City of West Linn

PRE-APPLICATION CONFERENCE MEETING

October 15, 2009

SUBJECT: Erickson Site as location for a new Elementary School
Assessor's Map 21E 23CD tax lots 12800, 12700, 12500 and
12301

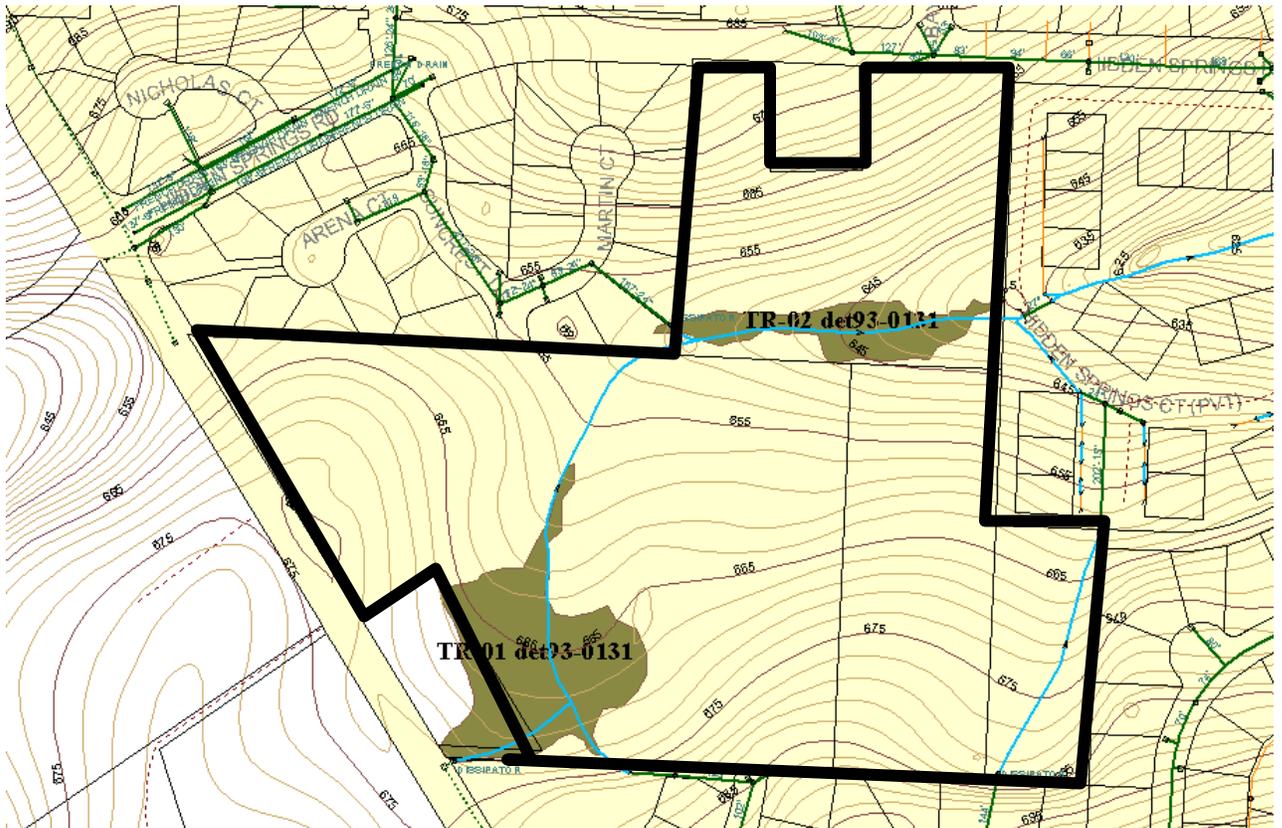
Staff also examined the storm drainage that originates in Cheyenne Terrace at the south east edge of the site. There is a storm water outfall with standing water, surrounded by indicator plants. During the summer months this water dissipates within 5-10 feet of the outfall. During rainy months, the flow is confined to very shallow almost indiscernible channels that braid through the area as well as sheet runoff before making their way north to a storm intake on Hidden Springs Court. Discussion with a neighbor during site visit, confirmed that this area is extremely wet and spongy at least six months a year. The applicant asked whether this section could be piped so that they could build a playing field in this area. Staff explained that CDC 32.050(B) requires that drainageways shall be maintained in their natural state. Thus staff could not support piping. Instead, the applicant could propose to create a functional well defined open channel with native vegetation along its bank.

Getting a complete wetland delineation from a wetland scientist or wetland specialist will be required for the “Cheyenne Terrace drainageway” before the definitive transition/setback can be determined. Wetland and stream restoration recommendations from the wetland specialist are appropriate.

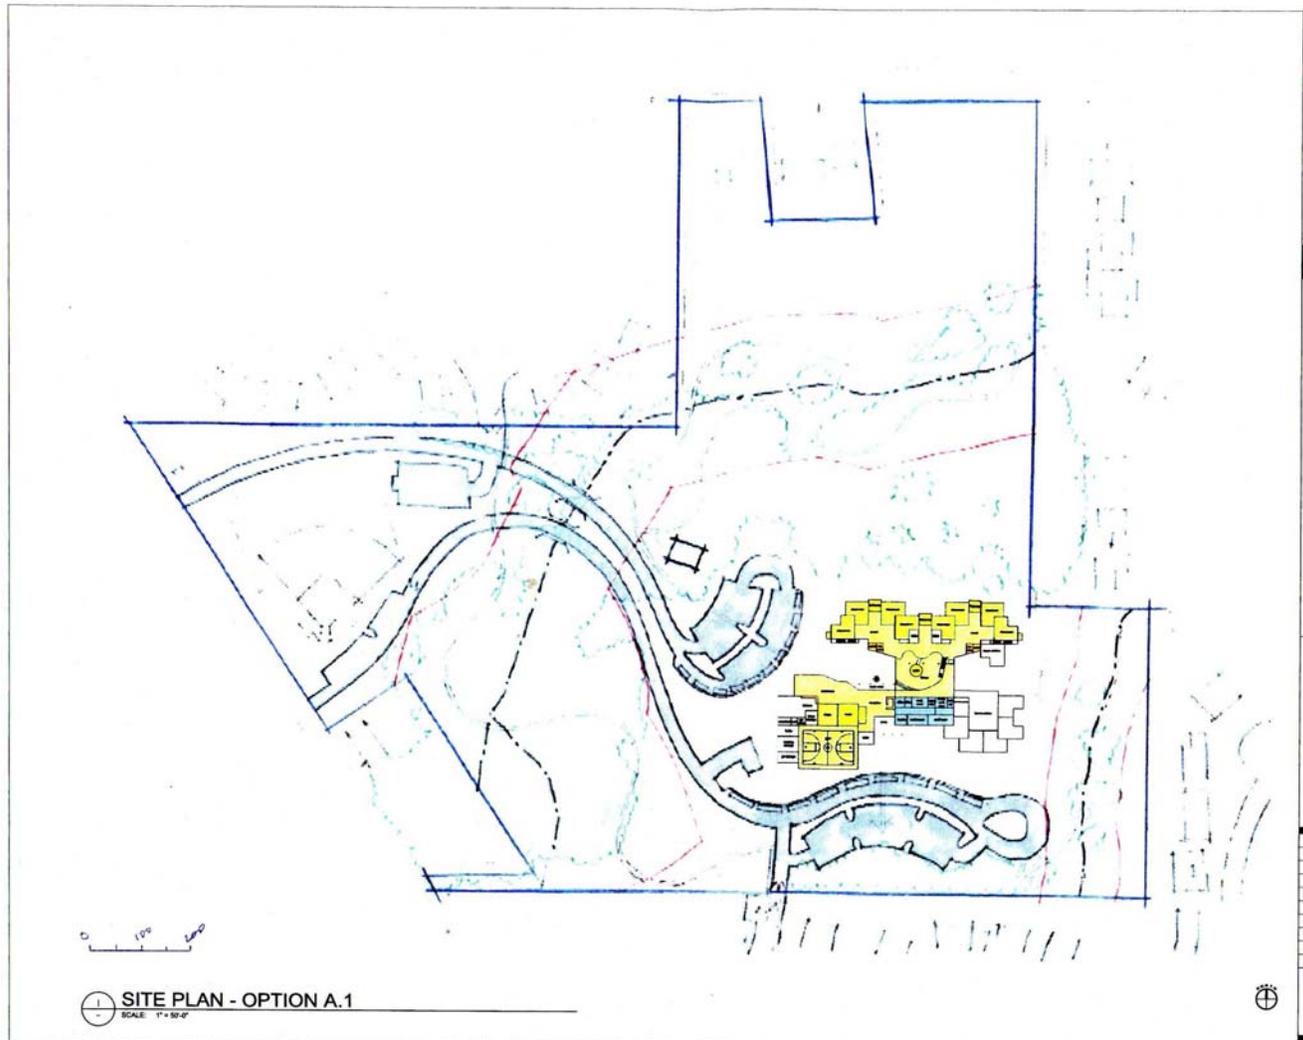
City Arborist, Mike Perkins, visited the site with Planning Staff on 10-08-09. During that visit he identified a sequoia at the west edge of the site as significant. He also noted a large number of oak trees on the site that could also be classified as significant. The site is also home to a large significant stand of mature Douglas Fir trees. The City Arborist stated that protecting the entire Douglas Fir community, that generally runs along the east-west stream axis, is very important to their survival and that removing trees around the edge of the collection would jeopardize the survivability of the entire community of trees.

The row of 20 foot high conifers adjacent to 20560 Martin Court and 20605 Suncrest Drive were not deemed significant nor was a parallel row of 20 foot high conifers just west of the stream channel. (Determinations of significance in this report cannot be considered official until the tree inventory is complete.)

CDC Chapter 55.100(B) (4) requires that if the trees are significant, then up to 20% of the site can be set aside for tree protection. A complete tree inventory is needed so the roads/driveways can be routed to avoid the significant trees to the degree possible. The tree inventory shall include mapping all trees and tagging them in the field with a number. The map will then identify each numbered tree by type and size (DBH). Once completed, the map will be forwarded to the City Arborist. At the pre-app the applicants stated that they had completed most of the required tree inventory. Once complete it shall be forwarded to the City Arborist for his review.

OPTION A.1

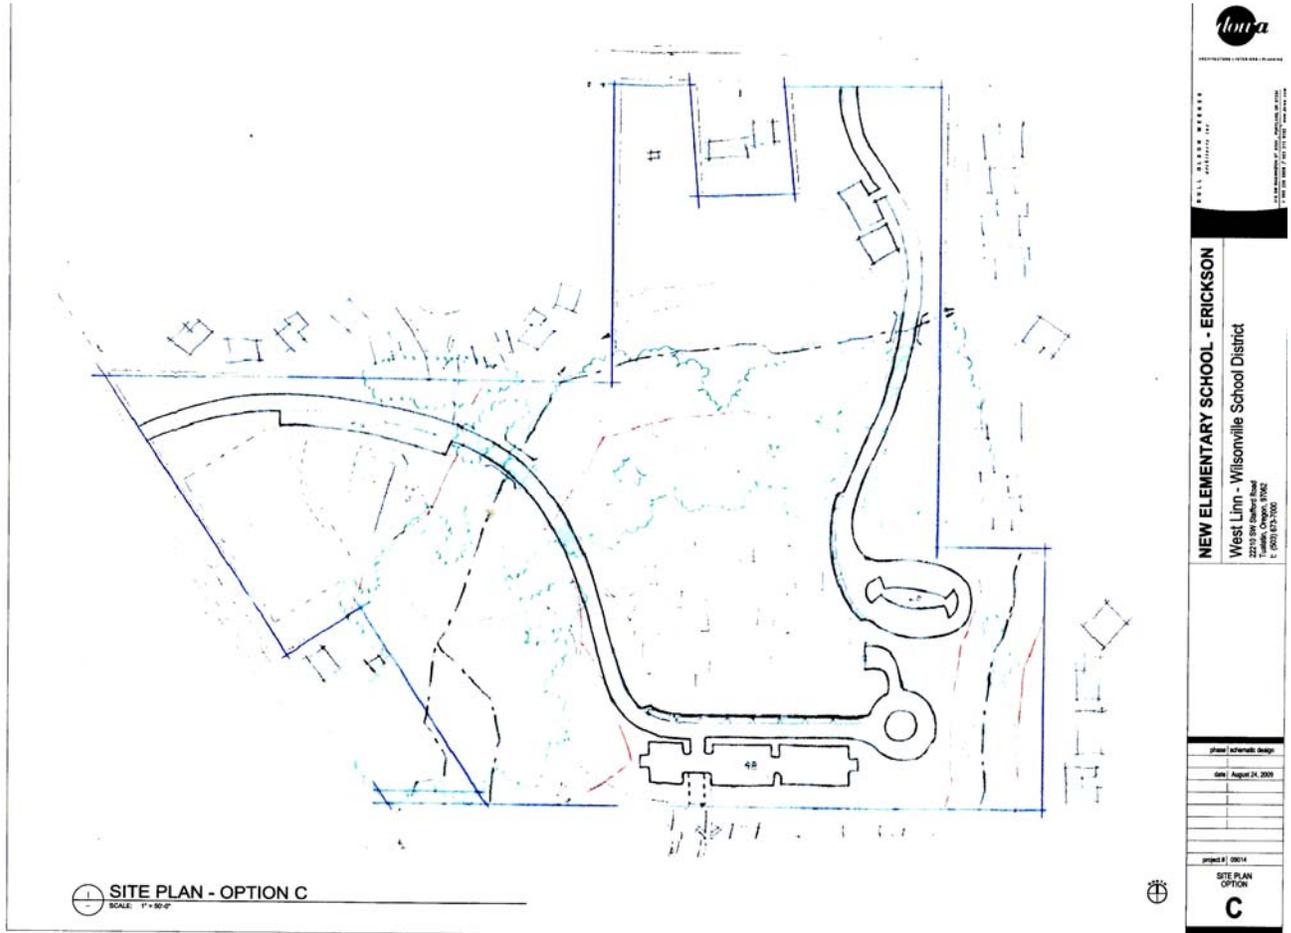
Both designs feature two creek crossings.

Option A.1 calls for two access points on Rosemont Road. The Engineering Department would prefer decreasing points of access onto Rosemont Road rather than increasing them, particularly since this road is an arterial with a currently posted speed of 40mph.

Option A.1 has two creek crossings almost side by side affecting a 200 foot long section of the wetland/creek area which begs the question: "Why can't the two crossings be reduced to one?" The neighbors most affected by this road alignment are in Arena Park subdivision to the northwest.
